## August BAR Decision

### Certificate of Appropriateness Application

BAR 20-07-07

422 1<sup>st</sup> Street North

A2.0

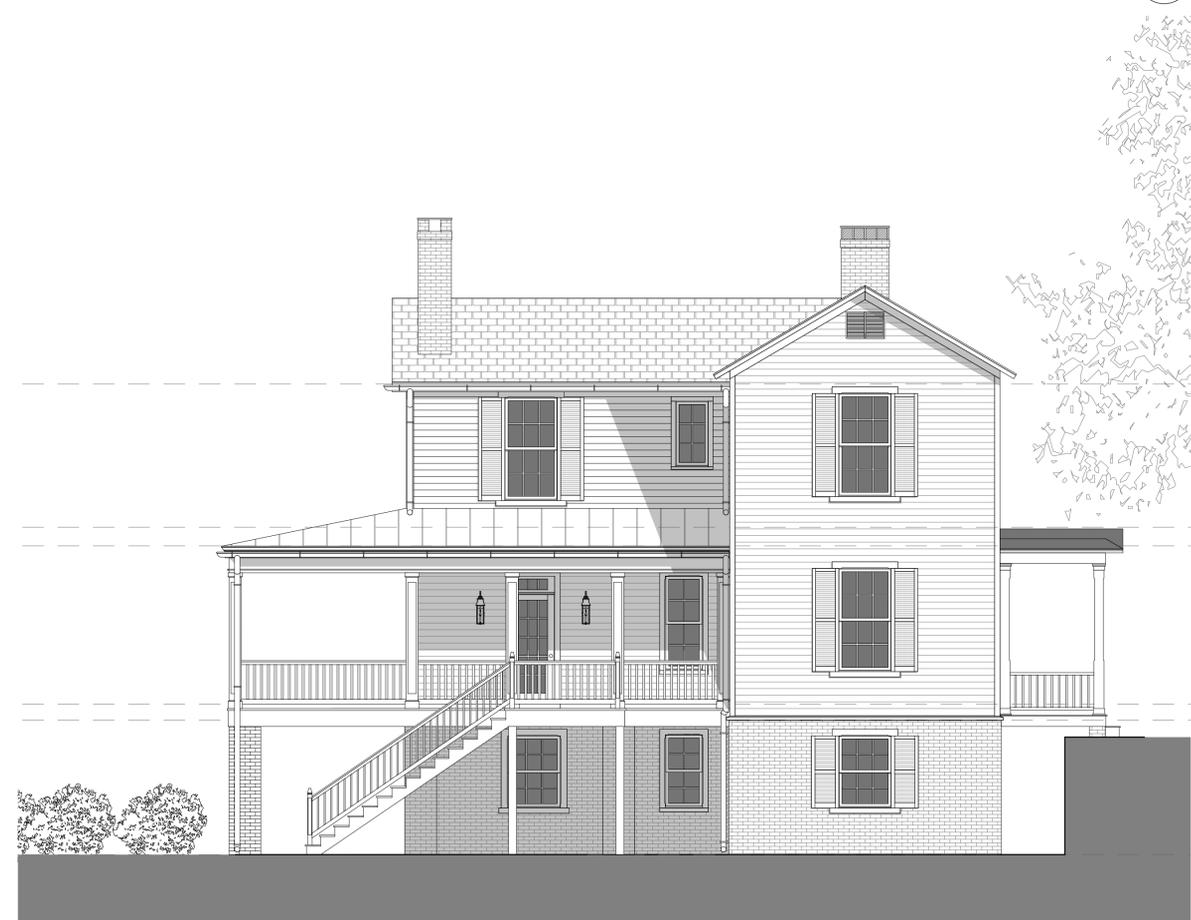
July 21, 2020 – BAR voted to defer the application. BAR generally supported the application, but requested the following items be submitted for clarification and action on the CoA request:

- The siding exposure and profile
- The proposed lighting
- The new shutters
- The roof peak and chimney location
- Upper roof material

- The new siding at the rear wing, upper addition will have a 6” exposure, contrasting with the 5-1/2” exposure for the existing siding.
- The proposed lighting has not been selected. See staff’s recommended conditions.
- The new shutters will be Timberlane solid-wood shutters, louver-style.
- The roof peak condition has been addressed. See sheets A2.0 and A.3.0.
- Chimney location noted. See sheets A2.0 and A.3.0.
- Roof material for the rear wing, upper addition to be asphalt shingles. (Owner may replace shingles on existing house, which will match those used on the addition.)
- Porch and sunroom roof to be standing seam metal, color *Charcoal Grey*.

Handrail and Picket Profile  
 SCALE: 1" = 1'-0"

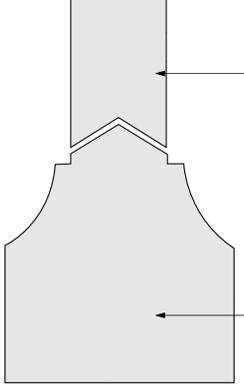
- Porch rail detail is shown on sheet A4.0.
- Windows to be Marvin, solid wood, with 5/8” muntin.
